**ADDENDUM  
NO. 1**

**March 17, 2025**

**PORTER LAKES ELEMENTARY SCHOOL  
ADDITION, RENOVATIONS, AND RELATED WORK  
Hebron, IN 46341**

This Addendum consists of Pages ADD 1-1, Specification Section 00 34 10 – Responsible Bidding Practices, and attached Addendum No. 1 from Gibraltar Design, Inc. dated March 14, 2025 and consisting of 6 pages, Specification Section 07 41 13 – Aluminum Roofing and 28 drawings.

**GENERAL NOTES:**

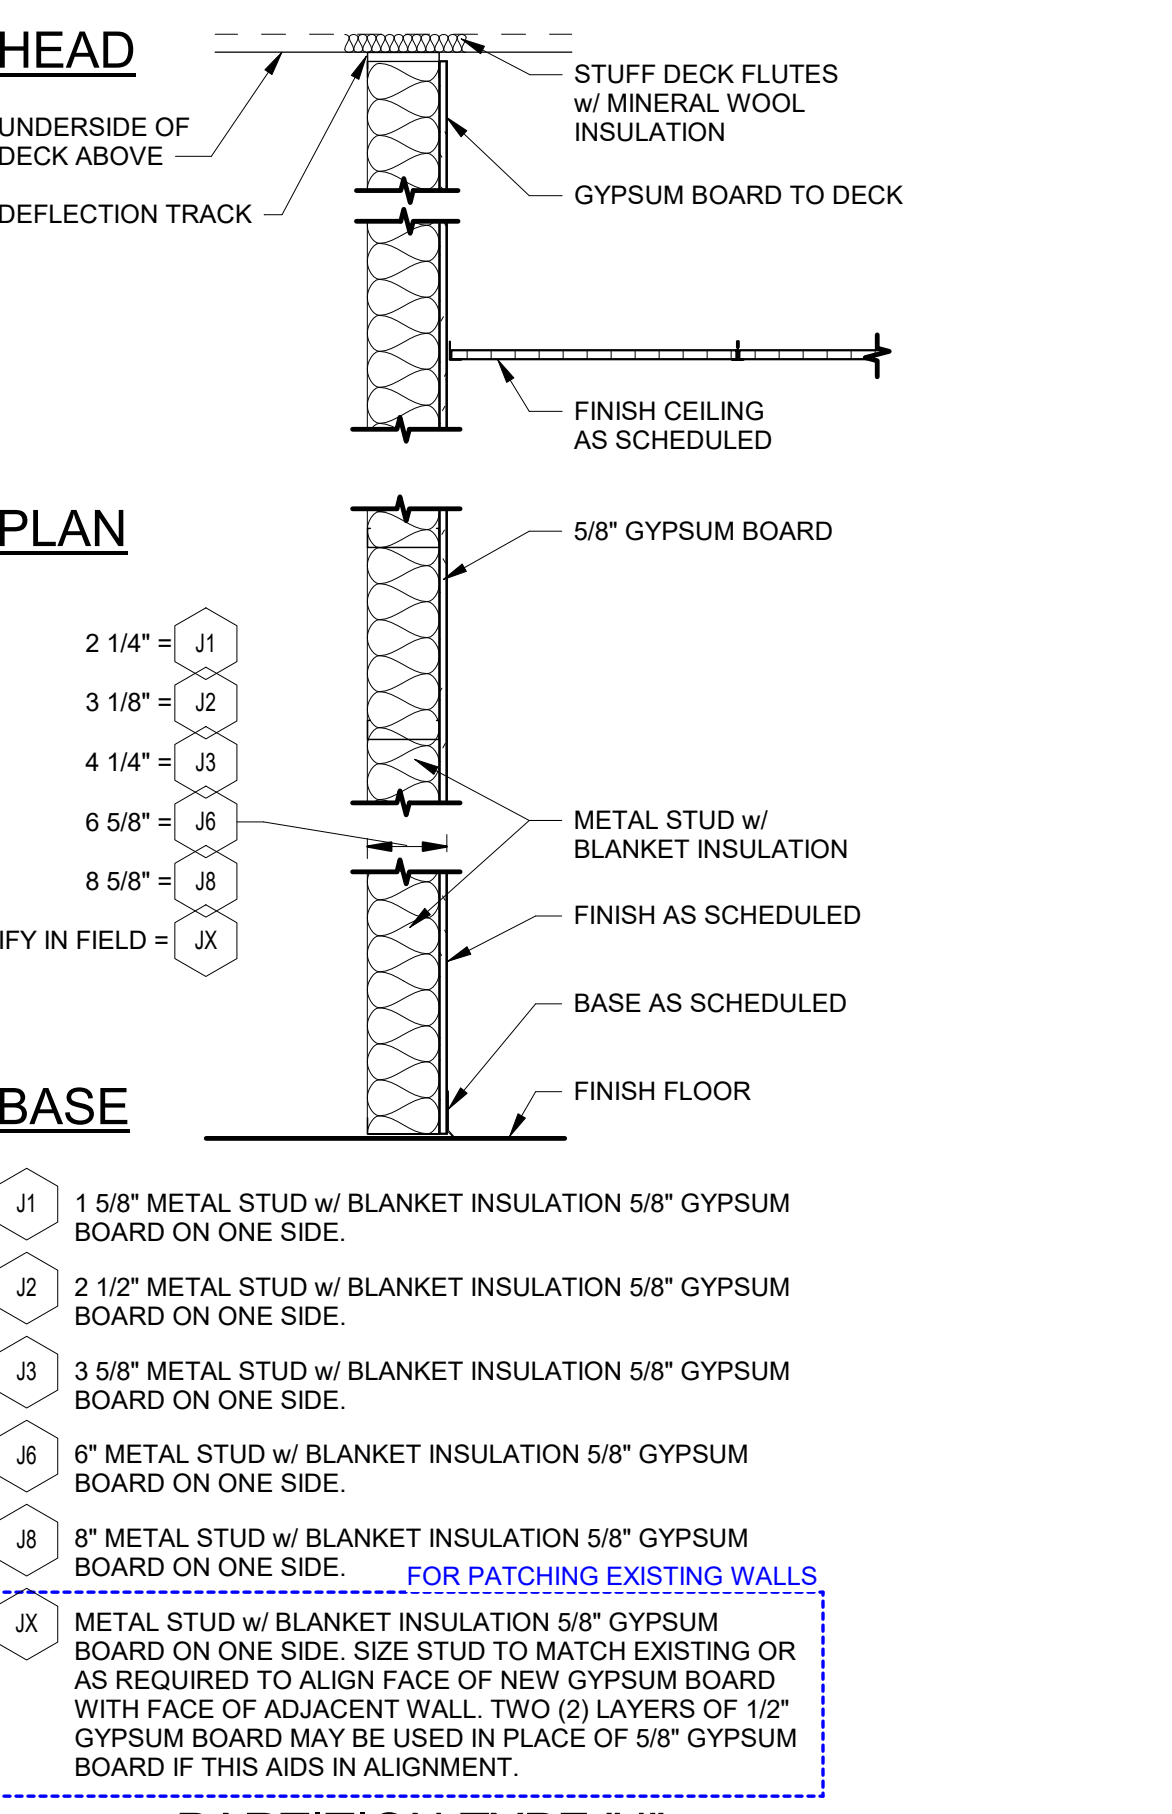
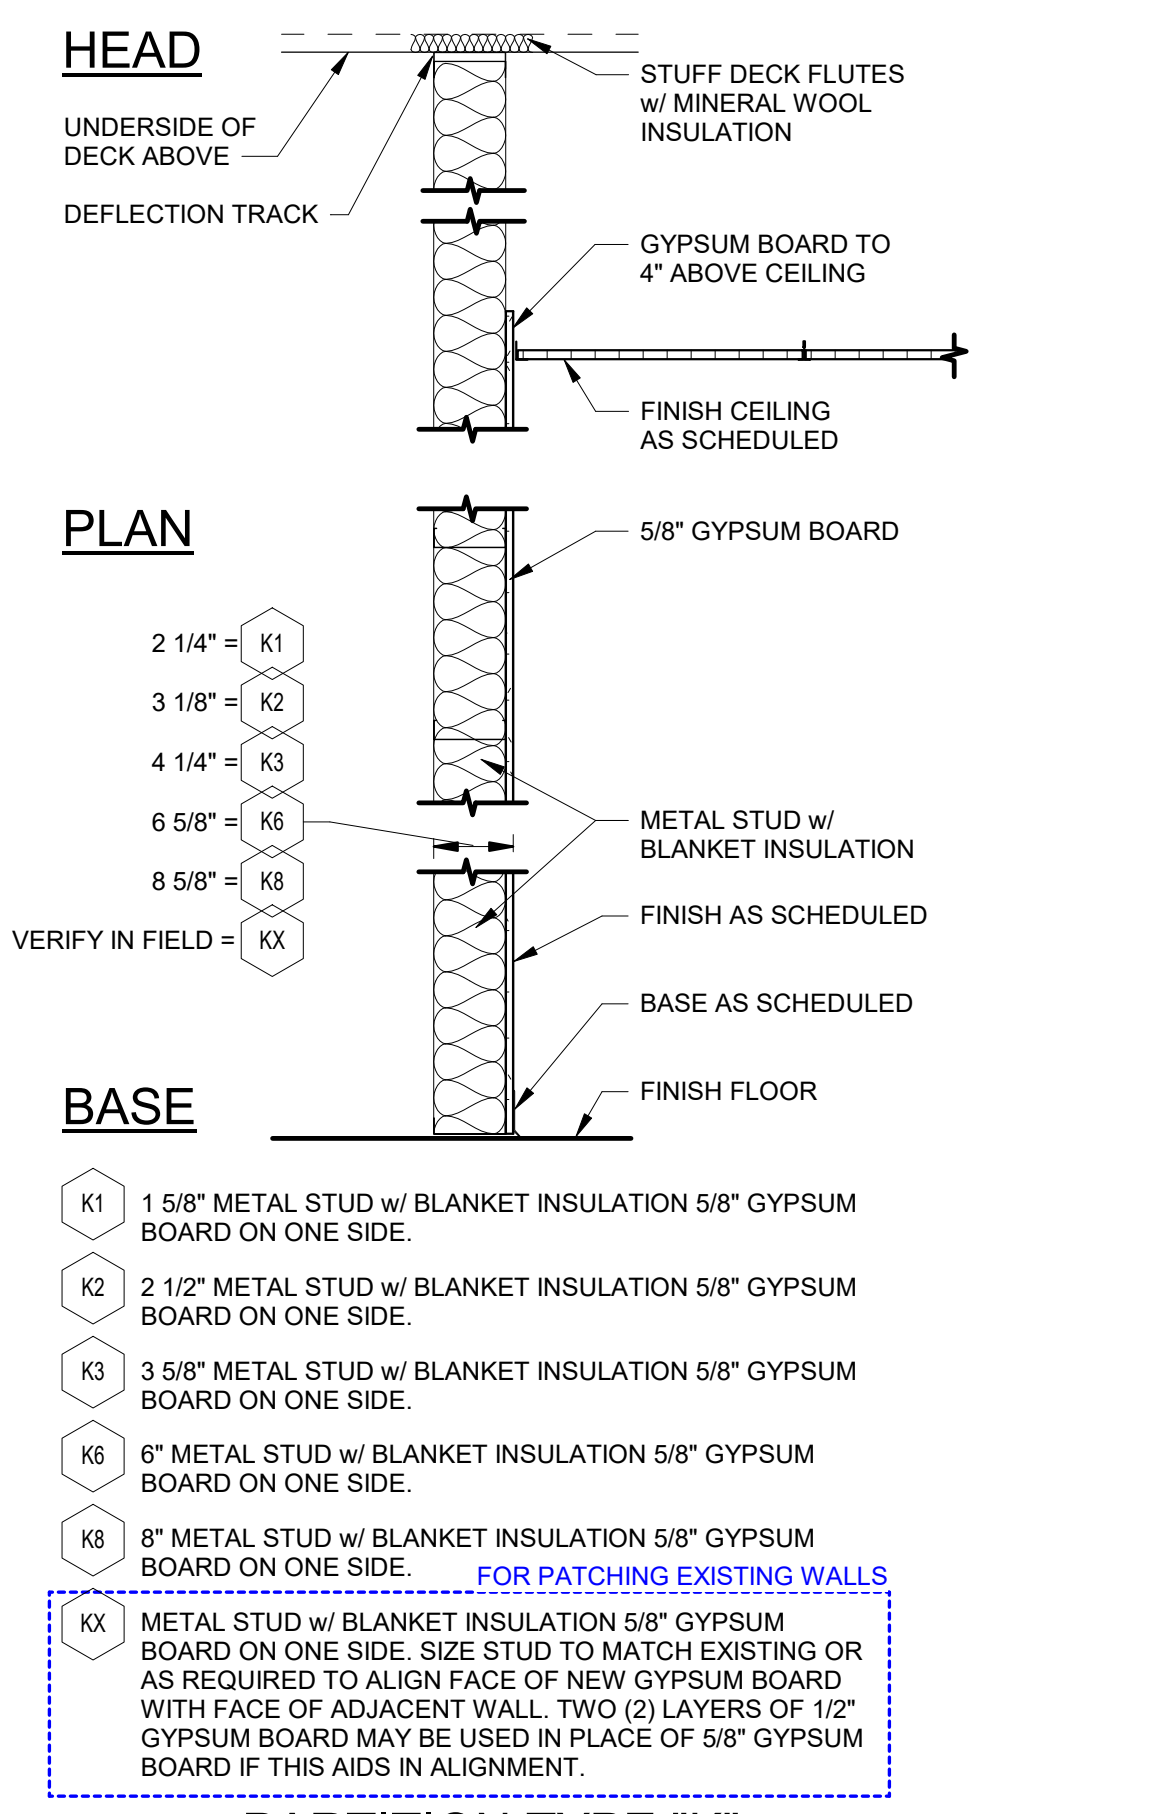
3. **Sheet G-101**
  - A. Revise the title for Sheet G-301 to read "GENERAL NOTES, SYMBOLS, ABBREVIATIONS, AND PARTITION TYPES".
4. **Sheet G-301**
  - A. Refer to revised, full-size drawing, included in this Addendum, for revisions.
    1. Renamed the sheet "GENERAL NOTES, SYMBOLS, ABBREVIATIONS, AND PARTITION TYPES"
    2. Added symbols, Material Indications, and General Notes
5. **Sheet C-1.1**
  - A. DEMOLITION NOTE 8, revise to read "REMOVE EXISTING METAL BUILDING AND CONCRETE FLOOR PAD. REFER TO ELECTRICAL SHEETS FOR RELOCATION OF ELECTRICAL FEED TO NEW METAL BUILDING TO THE WEST."
6. **Sheet C-4.1**
  - A. At RAMP DETAIL, remove dimensions and notes associated with the railing, and replace with a single note reading "NEW ALUMINUM RAILING. (REFER TO ARCHITECTURAL SHEET A-302)".

**1 FOUNDATION PLAN - AREA A**  
1/8" = 1'-0"

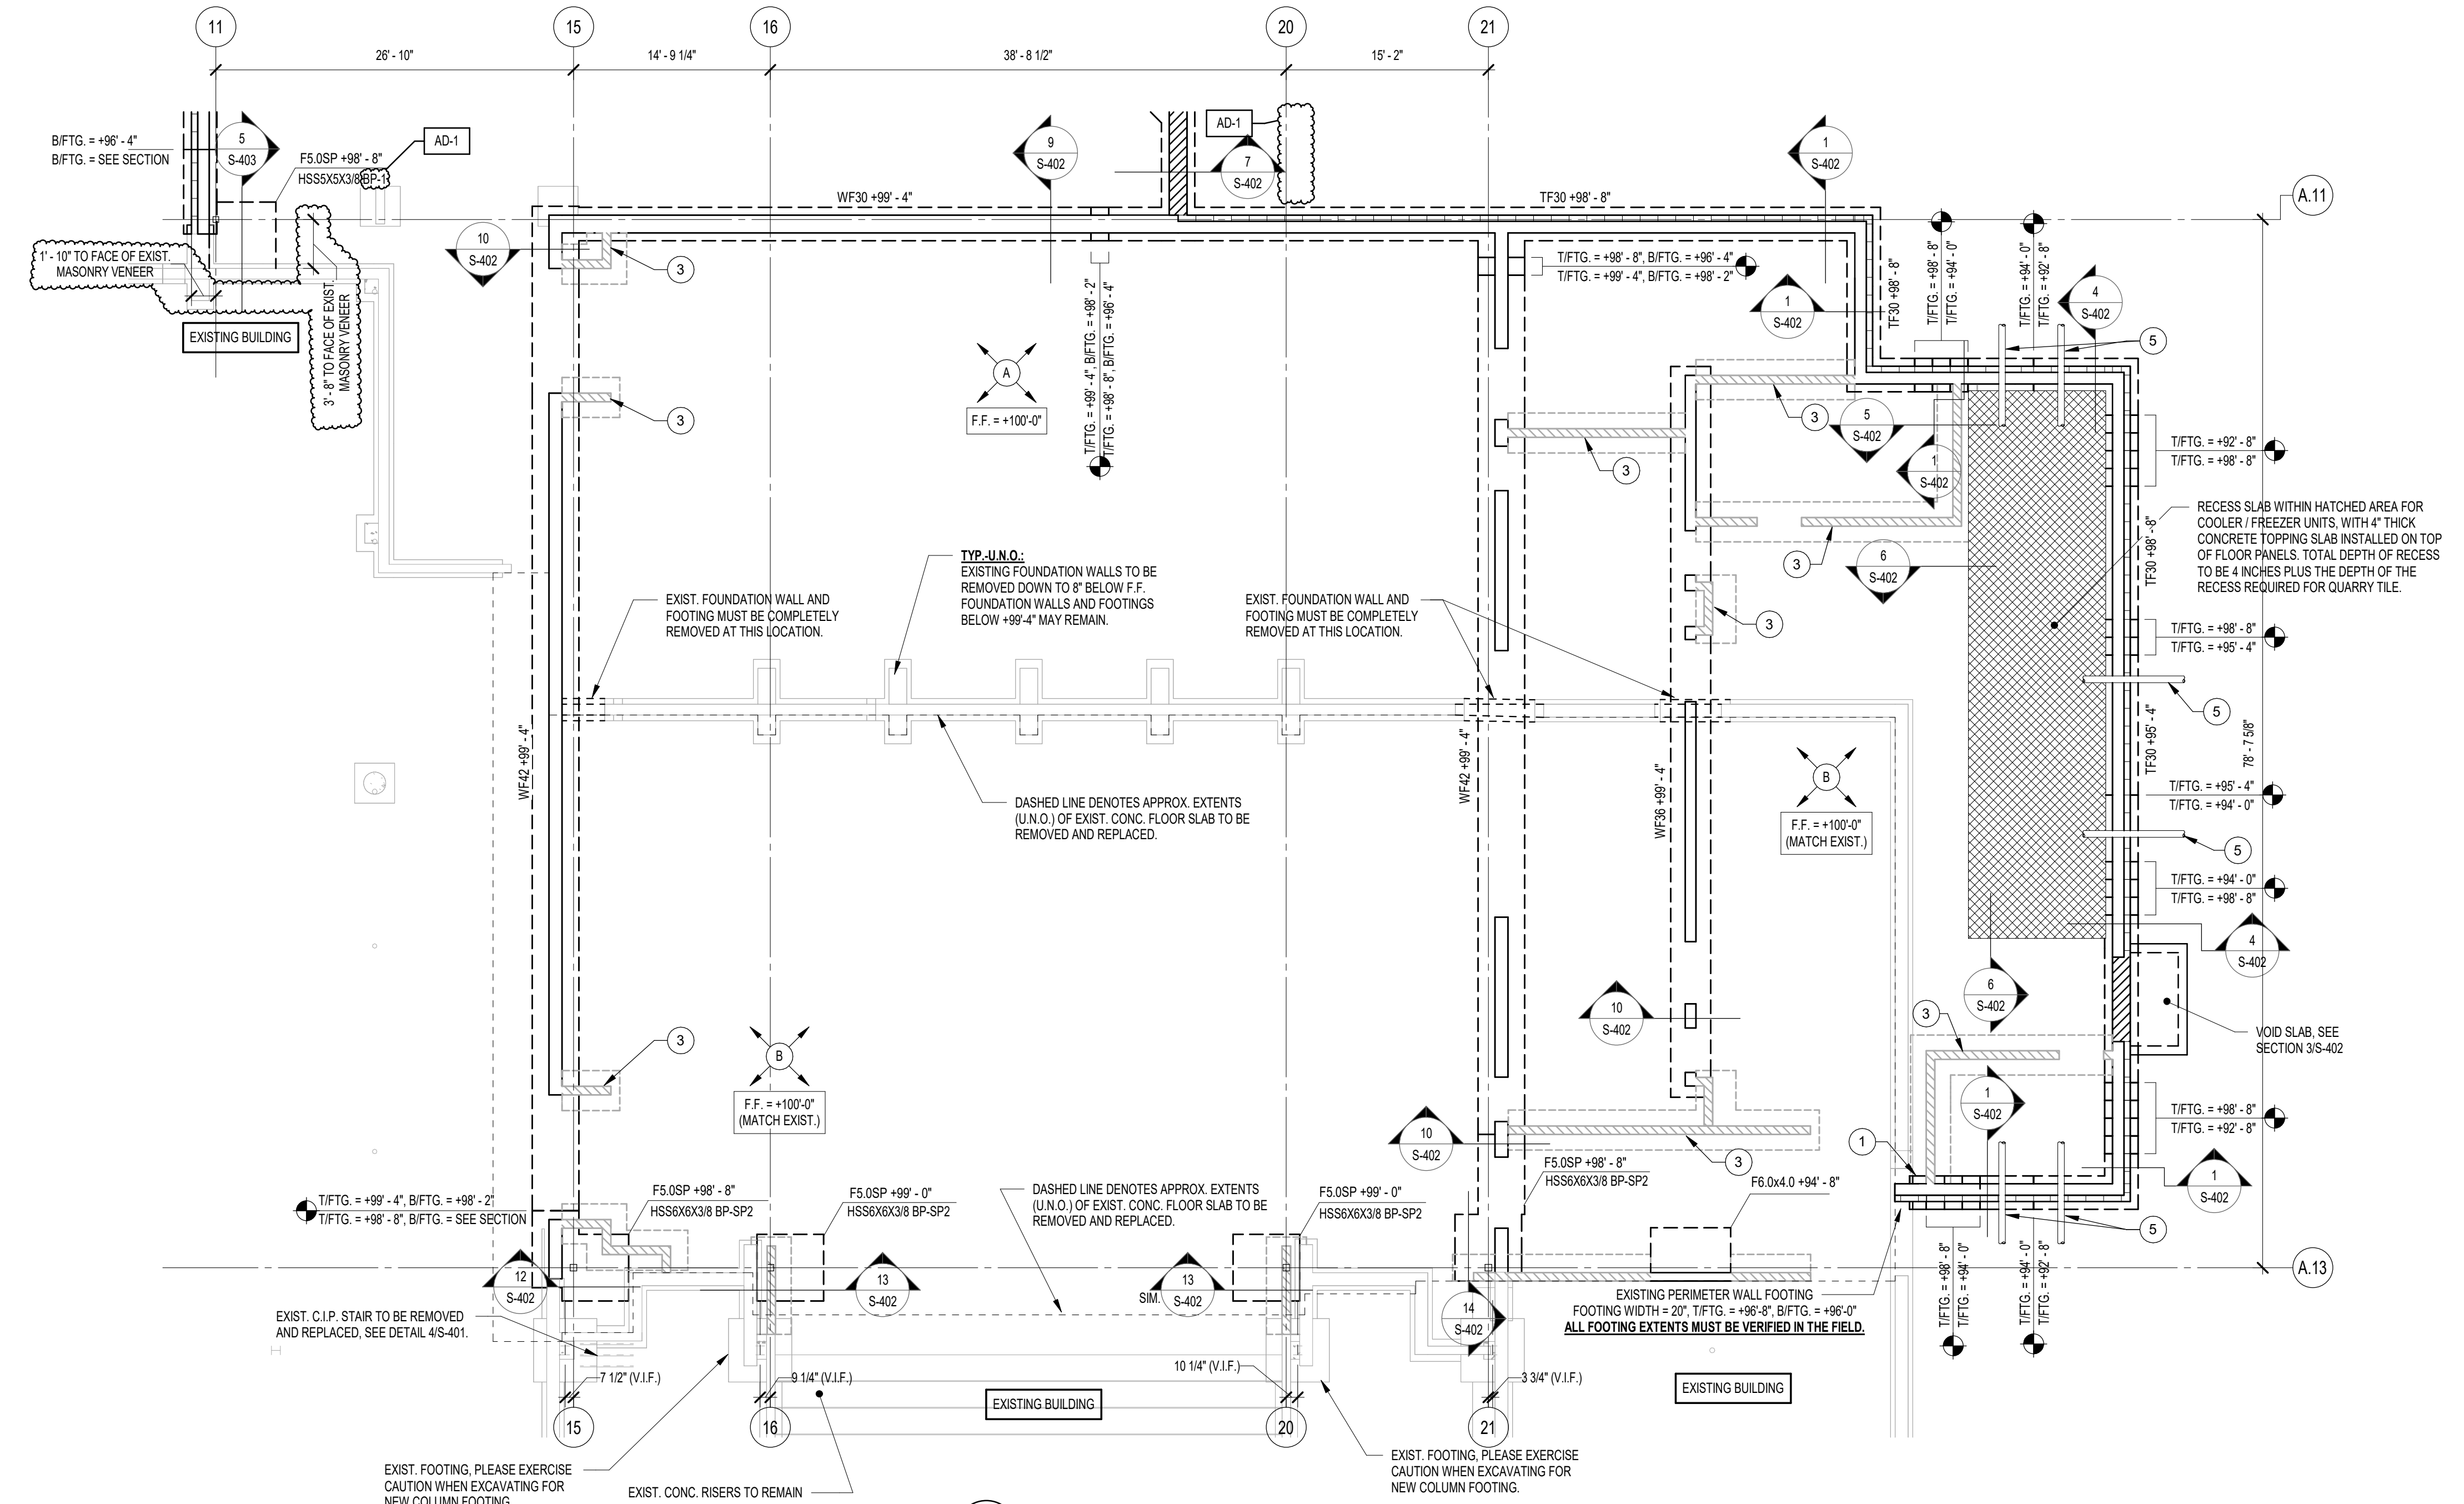
- A. Refer to revised, full-size drawing, included in this Addendum, for revisions.
  - 1. Held Dims. Provided between Exist. And Gridlines 11 & A.11
  - 2. Baseplate Designation at Grids 11 & A.11 Changed
